# UNITED STATES PATENT AND TRADEMARK OFFICE

APPLICATION NO.	FILING DATE	FIRST NAMED INVENTOR	ATTORNEY DOCKET NO.	CONFIRMATION NO.
09/740,053	12/20/2000	Kiyonori Shiraki	NIT-244	5572

**Office Action Summary**

**DETAILED ACTION**

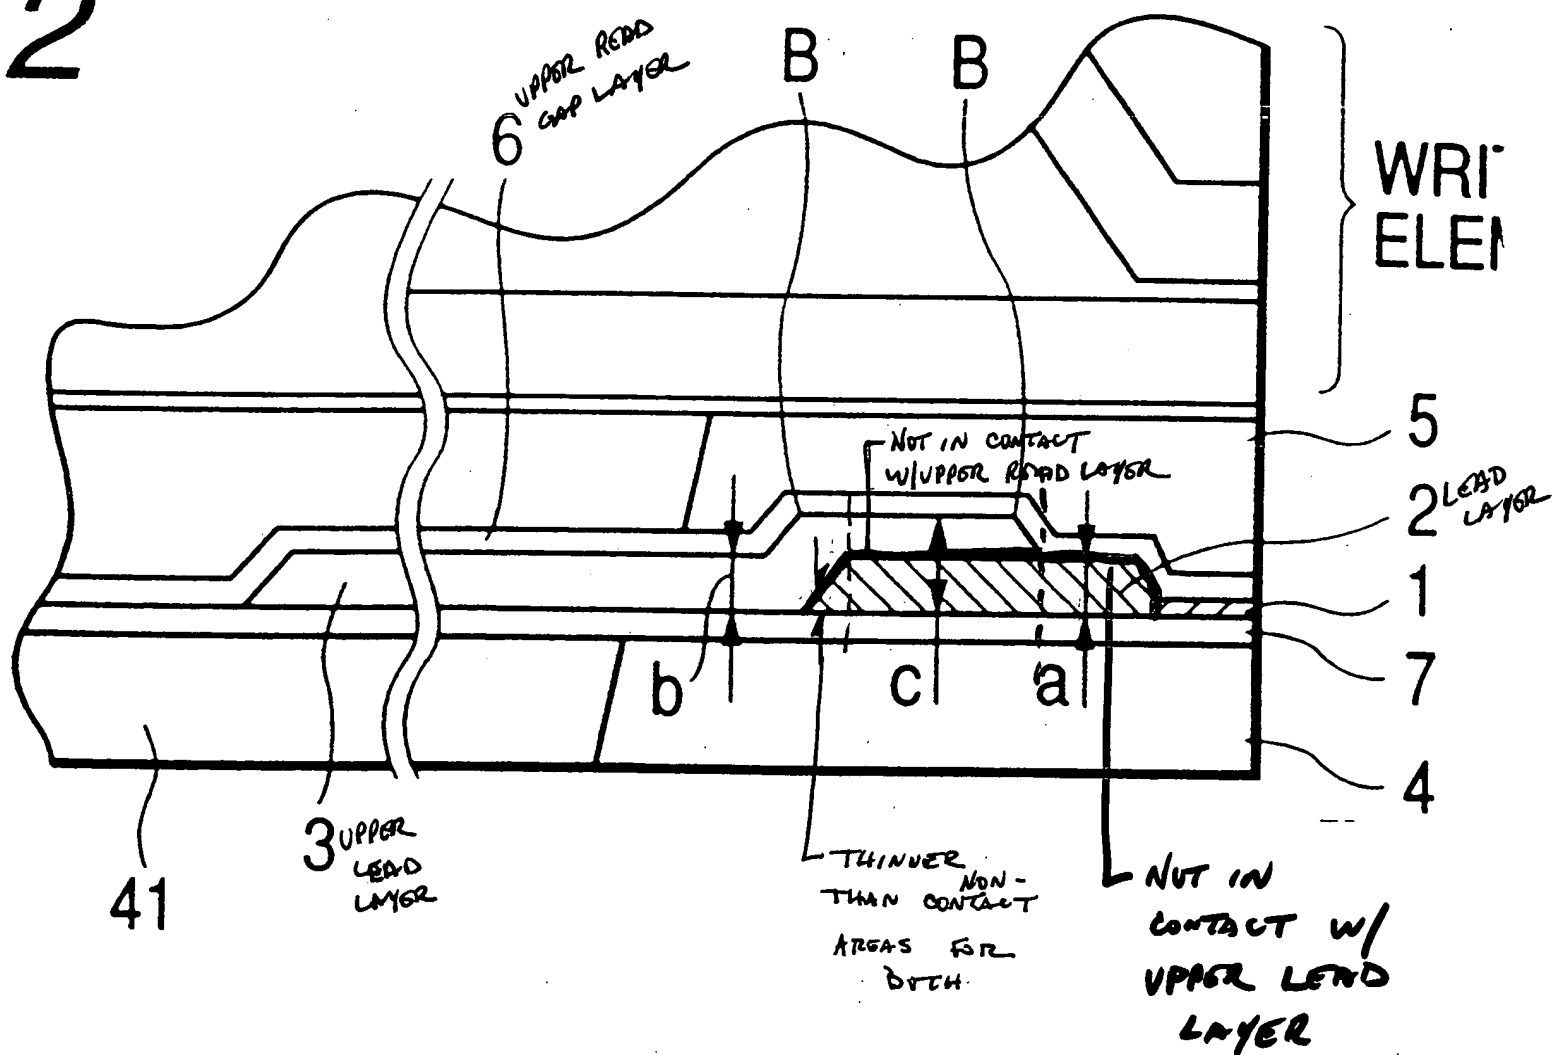
Figures 2 and 3 should be designated by a legend such as --Prior Art-- because only that which is old is illustrated. See MPEP § 608.02(g). A proposed drawing correction or corrected drawings are required in reply to the Office action to avoid abandonment of the application. The objection to the drawings will not be held in abeyance.

2. Claims 1 and 4 are rejected under 35 U.S.C. 102(b) as being anticipated by Applicant's Admitted Prior Art (hereinafter AAPA) (pg. 3, lines 4-15; Fig. 2).

- Regarding claim 1, AAPA shows an integrated thin film head, comprising:

a lower shield layer (4) formed on a substrate;  
a lower readgap layer (7) formed on said lower shield layer (4);  
a MR sensor layer (1) formed on said lower readgap layer (7);  
a lead layer (2) joined with said MR sensor layer (1);  
an upper lead layer (3) formed partially in contact with said lead layer (2);  
an upper readgap layer (6) formed to cover said MR sensor layer (1), lead layer (2) and upper lead layer (3); and

an upper shield layer (5) formed on said upper readgap layer (6) wherein a part of the lead layer (2) in contact with the upper lead layer (3) is formed thinner than the part thereof not in contact with the upper lead layer (3) (see attached Fig. 2).

- Regarding claim 4, AAPA shows an integrated thin film head, comprising:  
an undercoat layer (not illustrated) formed on the substrate (pg. 3, lines 7-9);  
a lower shield layer (4);  
a filler material filling (41) the stepped area of said lower shield layer;  
a lower readgap layer (7) formed on said lower shield layer (4) and filler material (41);

an upper shield layer (5) formed on said upper readgap layer (6) wherein a part of said lead layer (2) not in contact with the upper readgap layer (6) is formed thinner than the part thereof in contact with the upper readgap layer (6) (see attached Fig 2).
